Landmark Commission Agenda Via Conference - Zoom Wednesday, January 28, 2026, 7:00 p.m.

Memorandum

Re: **Certificate of Appropriateness: 18716 Scottsdale Boulevard—Proposed Roof Replacement.** Reece Berry and Matthew Miller, property owners.

Meeting: January 28, 2026

Proposed Asphalt Shingle in Shenandoah

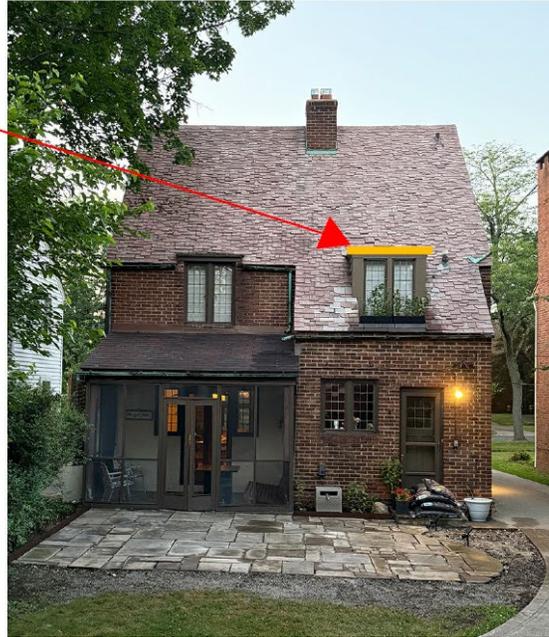
The homeowners are proposing to replace the existing asbestos shingle roof with new asphalt, Certainteed Landmark Pro Max Def shingles in Shenandoah. The homeowners will ensure that installation methods and accessory materials remain consistent with the character of the house. All roofing work will be performed by Renegade Roofing, an experienced contractor familiar with residential construction. The shingles will be installed using standard best-practice methods in accordance with manufacturer specifications.

1. The style and color of the asphalt shingle should follow the Landmark Commission's preference in a darker brown color range.
2. If the new gutter is not copper, it should be half round aluminum hung the same way as the existing gutters, in a brown finish to match the existing copper gutters.
